INTRODUCTIONCONCEPTS OF INHERENT SAFETY AS APPLIED TO THE UCLA ARGONAUT REACTOR

1. The review reported in the testimony which follows focuses on the question: Is the UCLA nuclear reactor inherently safe?

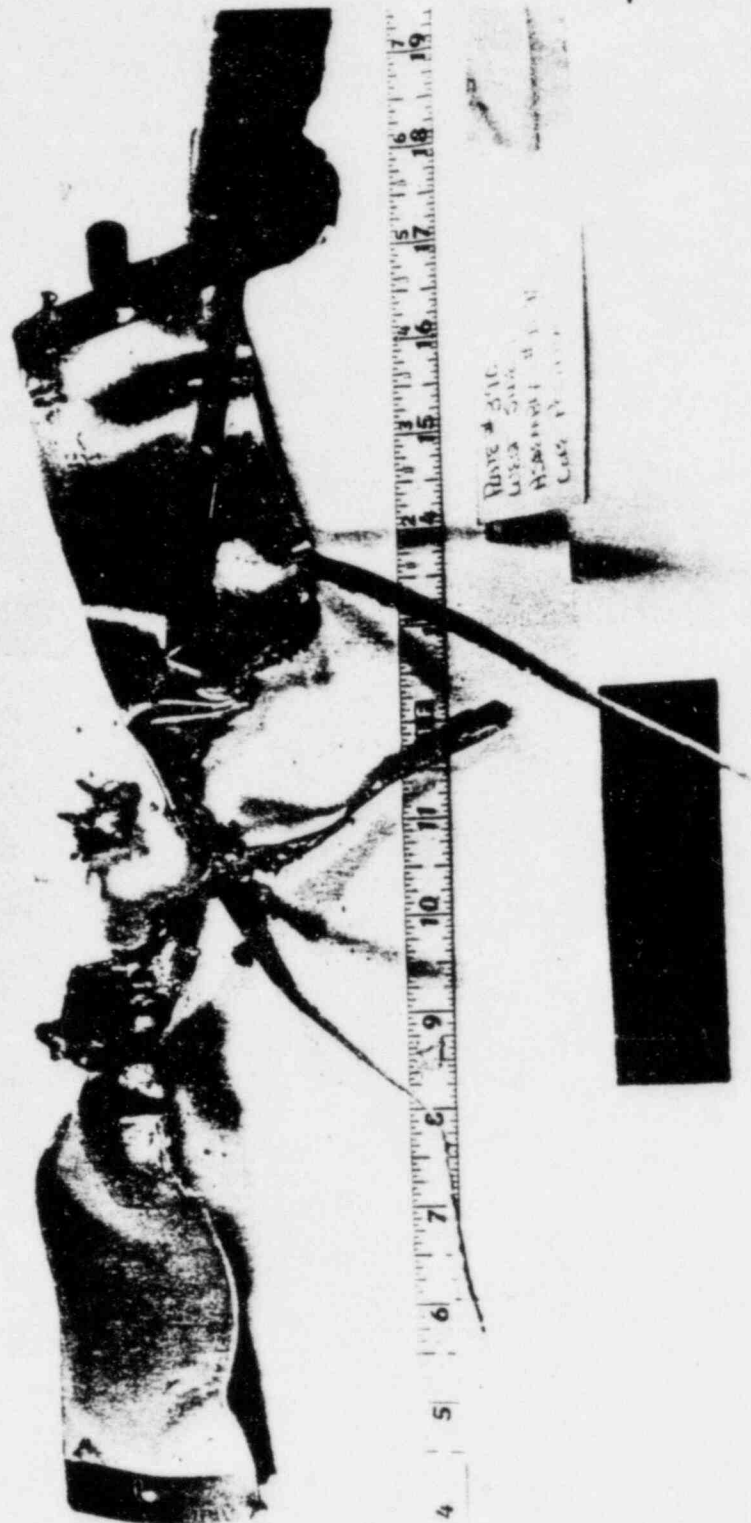
20. That simply isn't correct. In fact, the SPERT-ID reactor core was completely destroyed by a \$3.50 insertion, which resulted in explosive disassembly of the core and extensive melting of the fuel, as can be seen from the attached photos from that SPERT excursion.³

72. Even were it true that plate type fuel elements survived step insertions of \$3.54 at SPERT-- which they most certainly did not (as is plainly demonstrated in the photos of melted plates from the \$3.50 excursion found on pages 7 and 8)-- that would by itself say nothing about whether plate type fuel would survive the same insertion in the UCLA Argonaut, a different reactor design with significantly different operating characteristics. There is no magical relationship, as the UCLA statement cited in paragraph 69 above implies, between reactivity insertion and fuel plate response, independent of the reactor in which the excursion is occurring. A reactivity insertion of \$3.50 will melt one core, while leaving another virtually untouched, depending upon a whole litany of varying characteristics-- plate thickness, coolant channel width, void coefficient, moderator temperature coefficients, the presence of a non-expellable moderator such as graphite, the metal-water ratio in the core, plate surface area, degree of burnup and corrosion, prompt neutron lifetime, fuel enrichment and uranium weight %, starting moderator temperature, and many other factors.
